Access Compliance Report

Public Rights-of-Way

Intersection ID: 22417	Main Street: BRACKENBURY_LN	Cross Street: N_BRACKENBURY_LN	Location:	N
ADA ID: 02C3D6820899	Ramp Type: PerpDiag	Initial Pass/Fail: Fail	Overall Compliance: No	Severity Score: 8.75

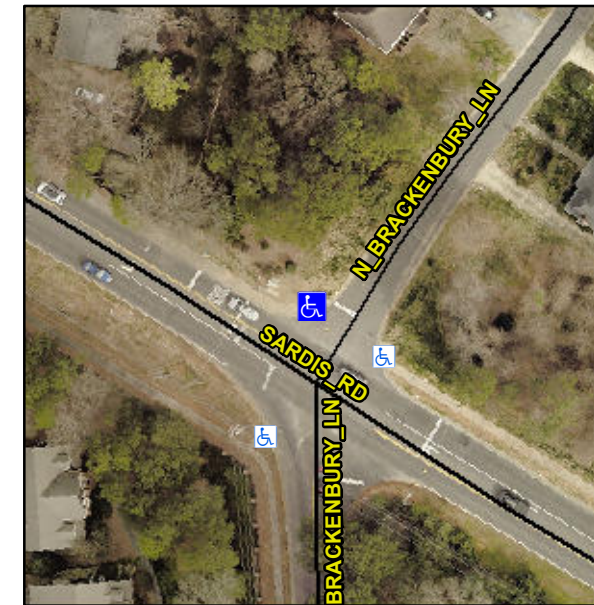
Not Found, R304.5.1

Compliance	Description	Data	Compliance	Description	Data
N/A	Ramp Length (in)	60.0	Yes	Ramp Slope (%)	5.4
No	Ramp Width (in)	40.5	Yes	Ramp XSlope (%)	0.7
N/A	Flare Type LT	N/A	N/A	Flare Type RT	N/A
N/A	Flare Slope LT (%)	N/A	N/A	Flare Slope RT (%)	N/A
N/A	Flare Traversable LT?	N/A	N/A	Flare Traversable RT?	N/A
N/A	Landing Length (in)	N/A	N/A	DWS Provided?	N/A
N/A	Landing Width (in)	N/A	N/A	DWS Contrast?	N/A
N/A	Landing Slope (%)	N/A	N/A	DWS Length (in)	N/A
N/A	Landing X Slope (%)	N/A	N/A	DWS Full Width?	N/A
N/A	Landing Curb? (Y/N)	N/A	N/A	DWS Offset (in)	N/A
N/A	Shared Landing?	N/A			
N/A	Gutter Ponding?	N/A	N/A	Gutter Slope (%)	N/A
N/A	Gutter Lip Ht (in)	N/A	N/A	Gutter X Slope (%)	N/A
N/A	Painted X Walk1?	No	N/A	Painted X Walk2?	No
	X Walk 1 Direction	To SW		X Walk 2 Direction	To SE
N/A	X Walk 1 Width (in)	N/A	N/A	X Walk 2 Width (in)	N/A
	X Walk 1 Slope (%)	1.1		X Walk 2 Slope (%)	2.6
	X Walk 1 X Slope (%)	2.8		X Walk 2 X Slope (%)	3.2

Remove & Replace Curb Ramp With Two New Directional Ramps or Equivalent.
